**FINAL OPERABLE UNIT 4 COMPLEX SILOS 1&2 IMPLEMENTATION PLAN FOR
ABOVE-GRADE DECONTAMINATION AND DISMANTLEMENT OF COMPONENTS
34A (SILO 2), 34B (SILO 1) AND SILOS 1&2 BRIDGES PAGE CHANGE NOTICE 1**

DOCUMENT NUMBER 40900-PL-0003 (REV. 0) PCN1

**OPERABLE UNIT 4 (OU4) COMPLEX SILOS 1 & 2 IMPLEMENTATION PLAN
FERNALD CLOSURE PROJECT RESPONSE TO USEPA COMMENTS FOR THE
COMPONENTS 34A (SILO 2), 34B (SILO 1), AND SILOS 1 & 2 BRIDGES ABOVE-GRADE
D&D PLAN**

FIGURE 1-1 Components 34A, 34B and Silos 1&2 Bridges PCN2

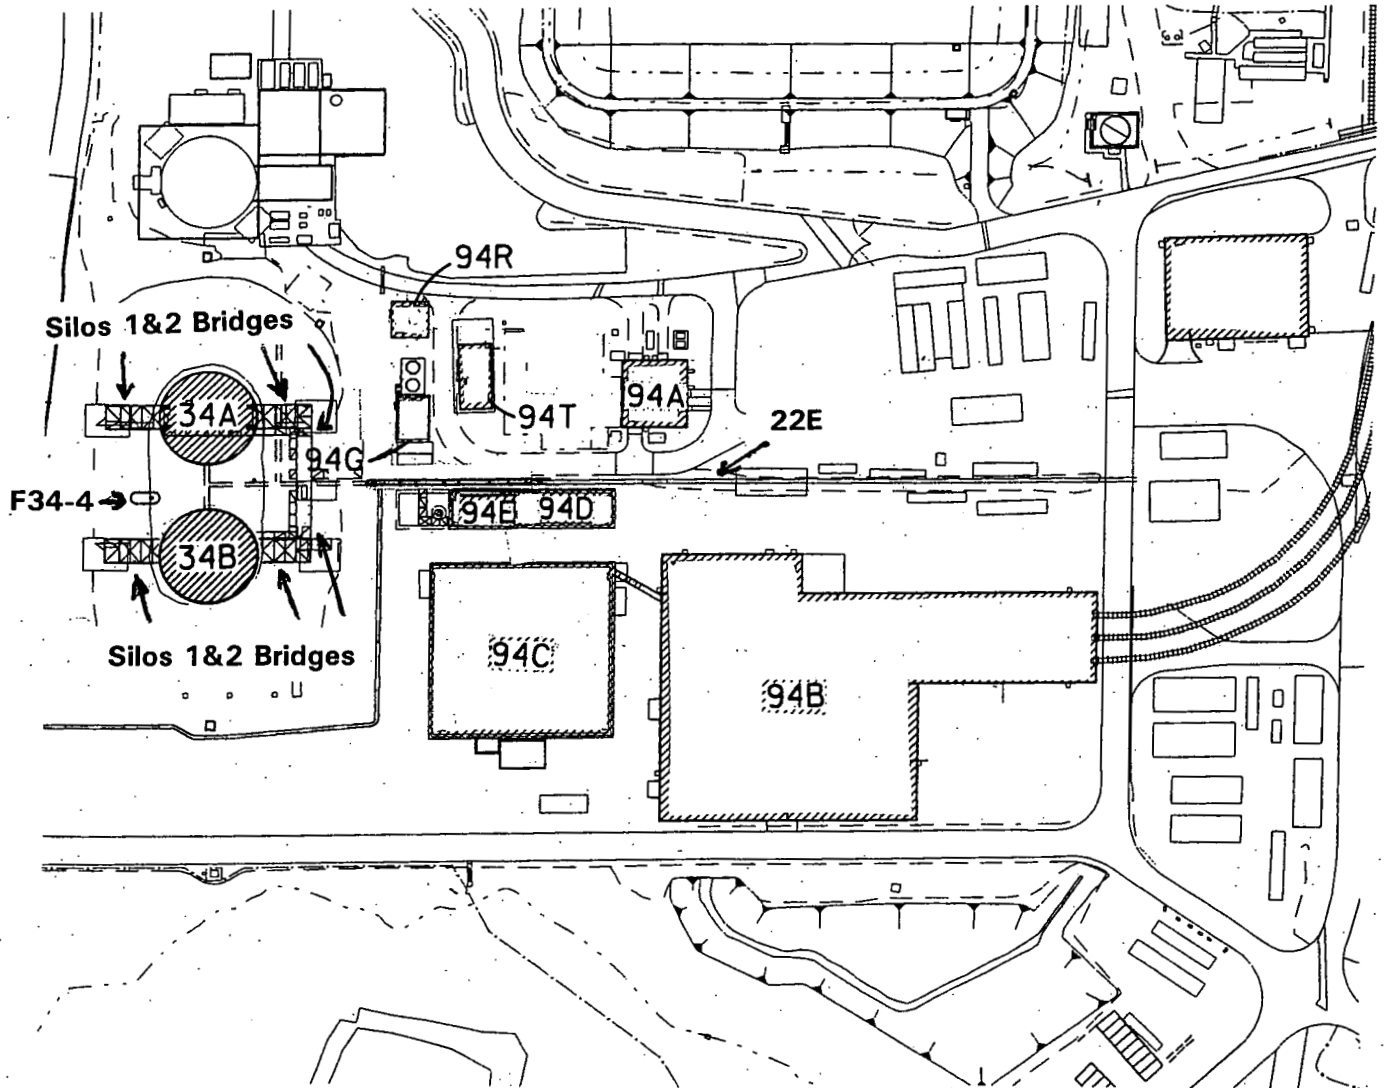
Comment: The text states that the Operable Unit 4 (OU4) components consist of Silo 1, Silo 2, the Silo 1 and 2 bridges, the K-65 Trench, and the Decant Sump Tank. All of these components should be shown and labeled in Figure 1-1.

Comment: Figure 1-1 should be revised to show and label the Silo 1 and 2 bridges, the K-65 Trench, and the Decant Sump Tank. Also, the figure should be revised to indicate the nature of Buildings 94A, 94B, 94C, 94D, 94E, 94G, 94R, and 94T.

Comment: The text discusses the concrete trench and steel piping system of the K-65 Trench. The K-65 Trench and its components should be shown and labeled in Figure 1-1.

Response: Figure 1 has been revised to identify the Silos 1&2 Bridges, the K-65 Trench and the Decant Sump Tank.

Response: Figure 1 has been revised to identify the Silos 1&2 Bridges, the K-65 Trench and the Decant Sump Tank. Figure 1-1 labeling of Buildings 94A, 94B, 94C, 94D, 94E, 94G, 94R and 94T was done to provide a clear layout of the Silos area. Since D&D of these buildings will be covered in a future implementation plan, indicating the nature of these buildings is not necessary in this implementation plan.

Response: Figure 1 has been revised to identify the K-65 Trench.
